Maroochydore City Centre

Priority Development Area Multi Deck Car Park (Lot 110)

AMENDED IN RED
By: Leila Torrens
Date: 23/12/2021

PLANS AND DOCUMENTS referred to in the PDA DEVELOPMENT APPROVAL
Approval no: DEV2021/1232
Date: 22 December 2021

DRAWING TITLE
FLOOR PLAN - LEVEL 00

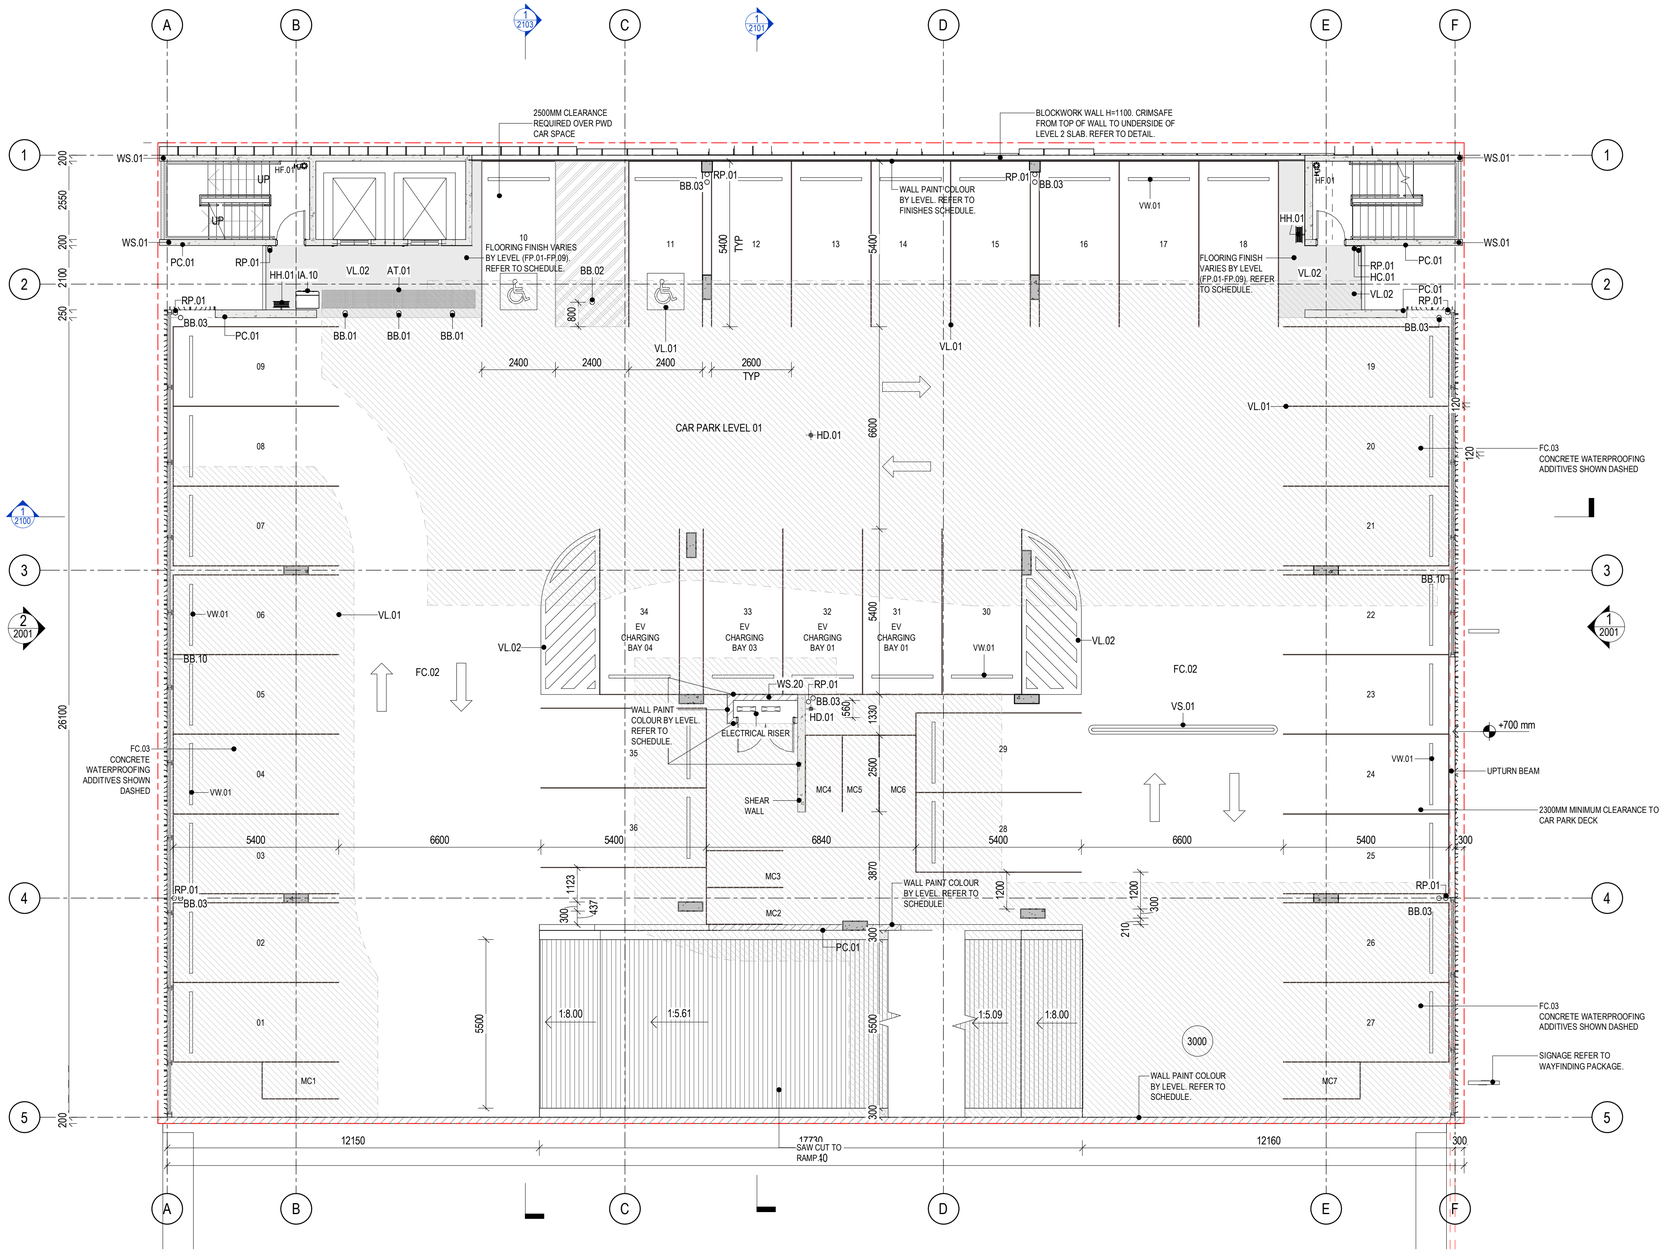
Splay to be provided in accordance with IPWEA standard drawing 051 with a 60 degree angle and 1500mm taper
